METROPOLITAN GOVERNMENT OF NASHVILLE AND DAVIDSON COUNTY

STAFF RECOMMENDATION
126 Windsor Drive
April 18, 2012

Application: New Construction—addition, Demolition—accessory structure.
District: Belle Meade Links Triangle Neighborhood Conservation Zoning Overlay
Council District: 23
Map and Parcel Number: 13001017100
Applicant: Jeff Steele
Project Lead: Melissa Baldock, melissa.baldock@nashville.gov

<p>Description of Project: Application is to construct rear addition and side porte cochere and to demolish detached car port.</p> <p>Recommendation Summary: Staff recommends approval of the demolition of the carport and the construction of the addition and porte cochere with the condition that staff review and approve the roof color, windows, doors, and a brick sample</p> <p>With these conditions, staff finds that the project meets II.B.1. and II.B.2. of the <i>Belle Meade Links Triangle Neighborhood Conservation Zoning Overlay: Handbook and Design Guidelines</i>.</p>	<p>Attachments A: Photographs B: Site Plan C: Elevations</p>
---	---

126 Windsor Drive, carport that will be demolished.

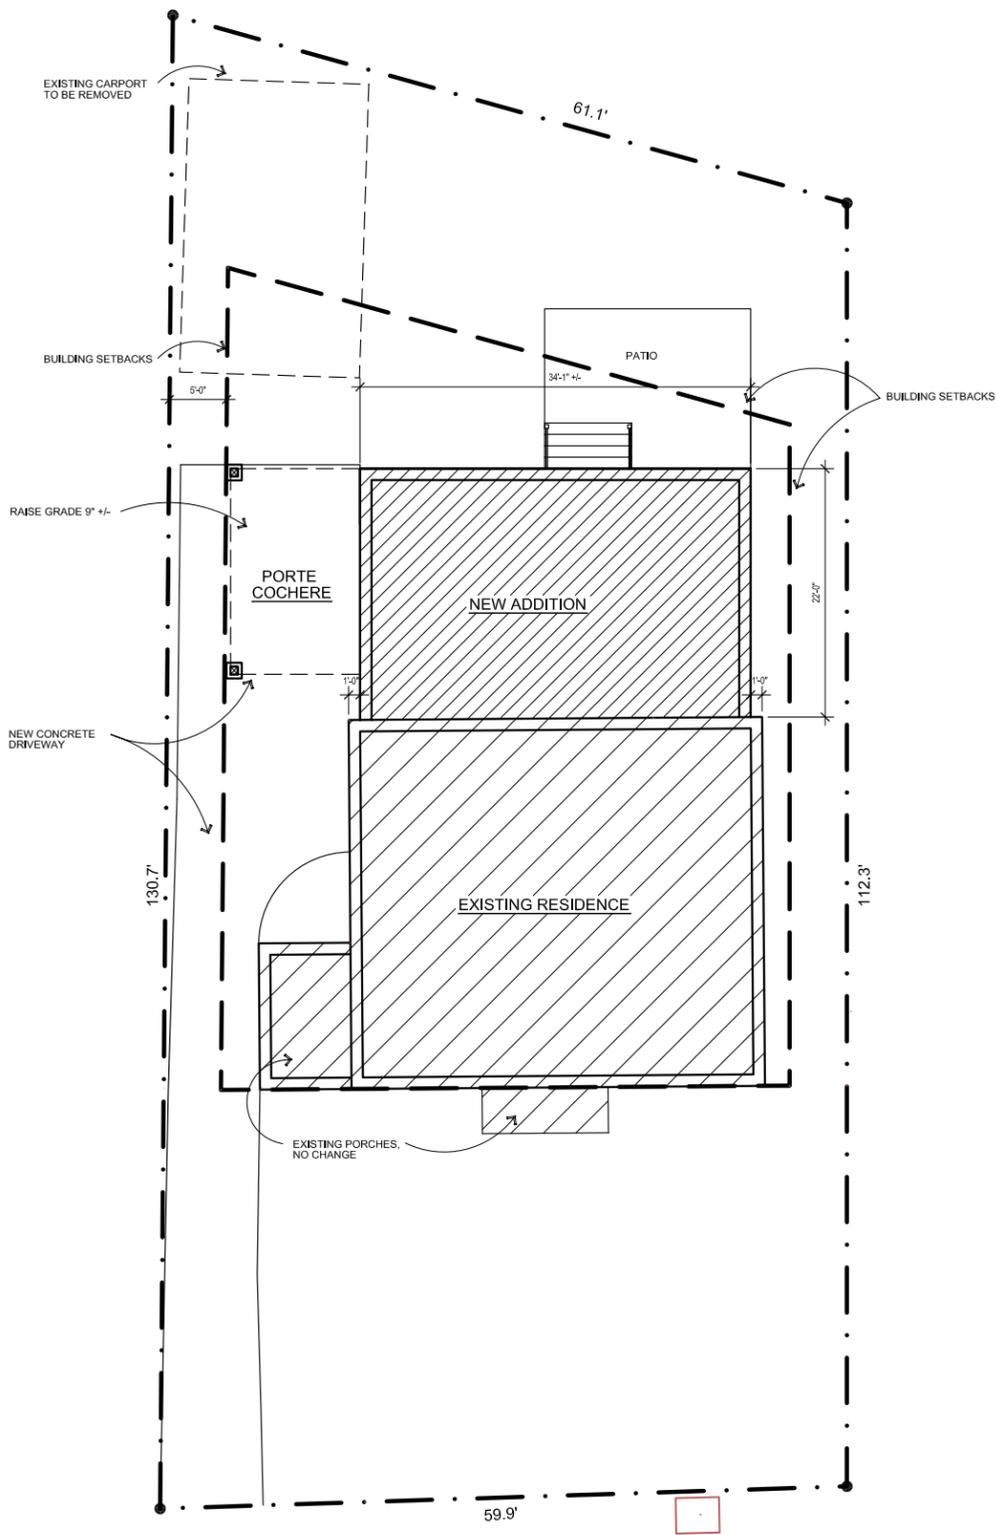
Demolition: Staff finds that the rear detached carport lacks architectural and historic integrity and therefore its removal meets Section III.B.2. of the *Belle Meade Triangle Links Neighborhood Conservation Zoning Overlay: Handbook and Design Guidelines*

ARCHITECTURAL SITE PLAN

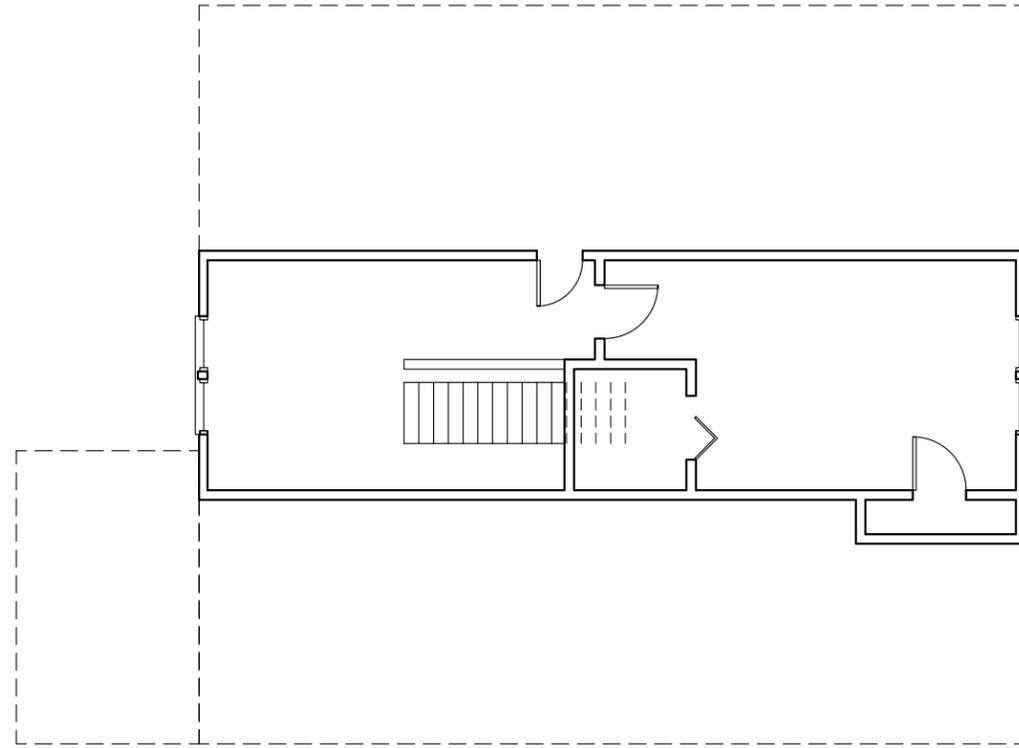
Location & Setback: The proposed addition and new carport meet all base zoning requirements for setbacks. The addition is set entirely behind the historic house, and its footprint is inset one foot (1') from each of the side walls of the house. The addition will

The carport, which will attach to the left side of the addition, towards its back, does extend beyond the side wall of the main portion of the historic house by ten feet, eight inches (10'8"). However, there is an existing screened porch at the front of the historic house, and the carport will only extend two feet, eight inches (2'8") beyond this porch. Additions that are wider than the historic house are generally appropriate when the historic house is less than thirty feet (30') wide or the house is shifted to one side of the lot. In this instance, the house is more than thirty feet (30') wide, but the bulk of the house is shifted towards the right side of the lot. Staff therefore finds the location of the carport to be appropriate. In addition, staff finds the carport appropriate because the existing screened porch will help to obscure its visibility, and because it will be largely open in nature.

Staff finds that the location and setbacks for the proposed addition and carport meet sections II.B.1.c. and II.B.2.a. of the *Belle Meade Triangle Links Neighborhood Conservation Zoning Overlay: Handbook and Design Guidelines*.

REMODELED WEST ELEVATION

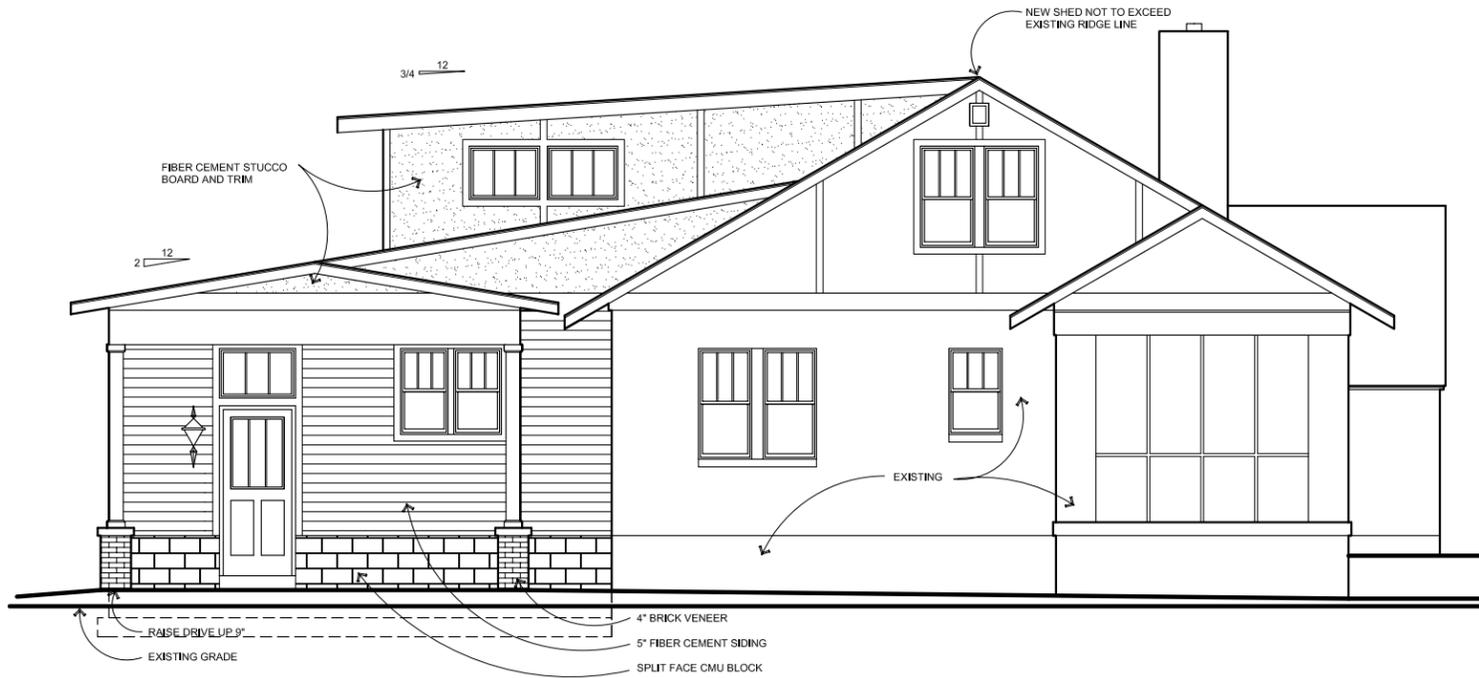
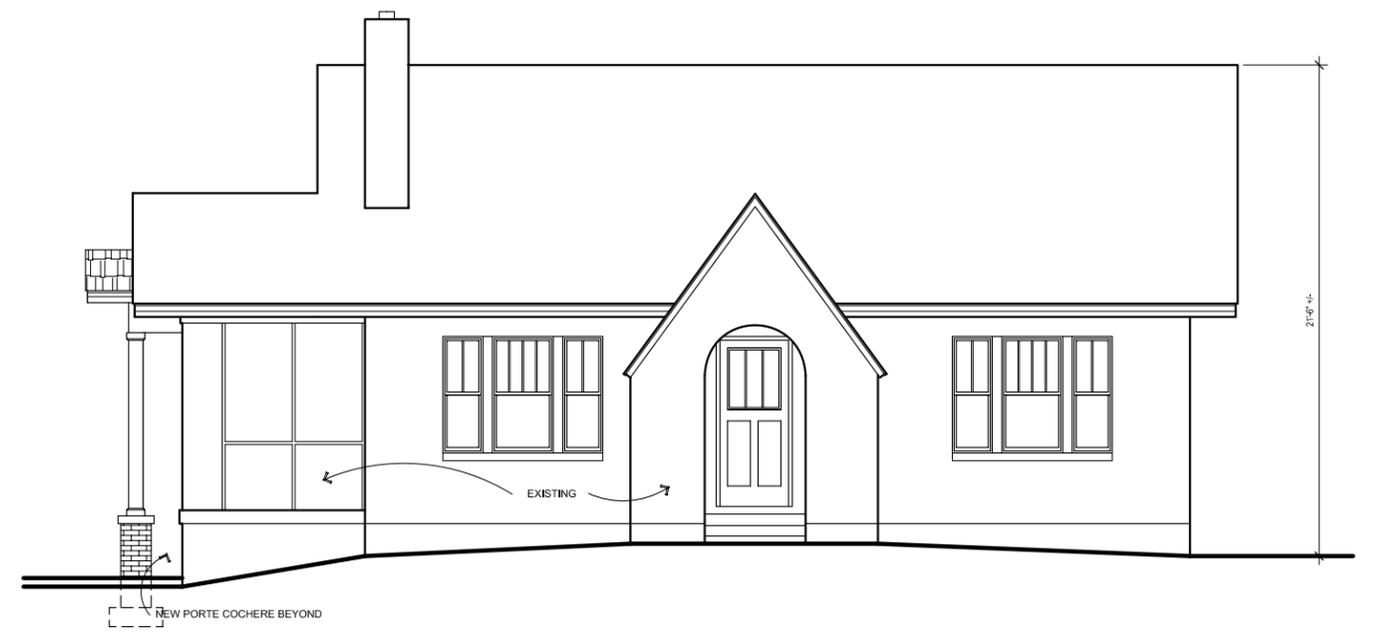
The addition's first floor level will have an eave height of thirteen feet, three inches (13'3") and a ridge height of approximately seventeen feet, eight inches (17'8"). The rear dormer will meet the ridge of the house, and the addition's foundation will match the height of the house's foundation. The carport will have an eave height of thirteen feet, three inches (13'3") and a ridge height of fourteen feet, four inches (14' 4").

Materials, Texture, and Details and Material Color: The addition will primarily be clad in fiber cement siding with a five inch (5") reveal, although the dormer and the gable field of the porte cochere will be clad in fiber cement stucco board and trim. The foundation will be split face concrete block. The addition and the porte cochere's roof will be asphalt shingle, while the dormer's roof will be rubber membrane. The porte cochere will have wood columns and brick bases. Staff asks to approve a brick sample. The materials for the windows and doors were not specified, and staff asks that a condition of approval be that staff review and approve the window and door material and specifications prior to purchase and installation.

Roofs: The historic house's primary roof form is a side gable with a pitch of approximately ten-twelve (10/12). The addition will have a shed roof with a roof pitch of two-twelve (2/12); the porte cochere will have a side-gable roof with a pitch of two-twelve (2/12); and the dormer will have a shed roof with a pitch of three-fourths to twelve (3/4-12).

Proportion and Rhythm of Openings: The dimension and design of windows and doors are similar to those on the existing house. The primary windows on the addition are taller than they are wide and therefore fit the proportions for historic window openings. There are no large expanses of wall space without a window or door opening on any of the facades.

Staff recommends approval of the demolition of the carport and the construction of the addition and porte cochere with the condition that staff review and approve the roof color, windows, doors, and a brick sample
